Service Bulletin

Bulletin No.: PIT6464A

Subject: Fifth Wheel Hitch Does Not Latch Into Factory Box Mounted Hitch

7030038

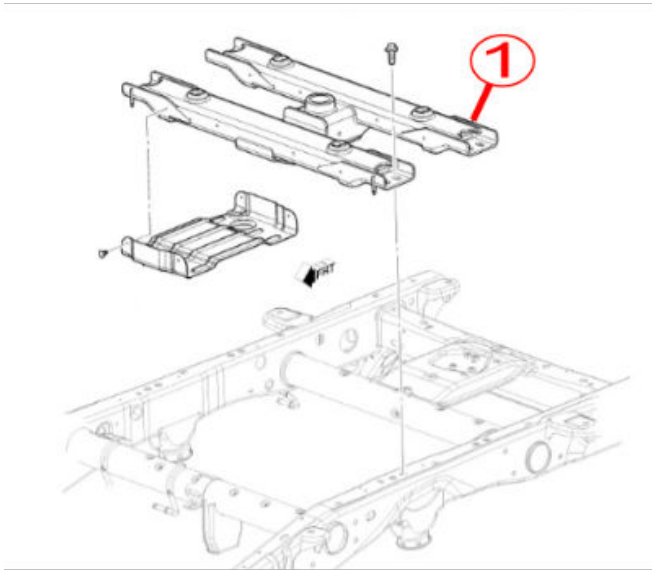
Involved Region or Country	North America
Additional Options (RPO)	Z6A Gooseneck / 5th Wheel Prep
Condition	A customer may comment that their Fifth Wheel Hitch will not latch / lock into the factory box mounted hitch locations.
Cause	The Box Mounted Trailer Hitch may be welded incorrectly due to a supplier quality concern.

Replace the Box Mounted Trailer Hitch (#1 below) to correct this concern. Use EPC to locate the correct Box Mounted Trailer Hitch using the VIN number.
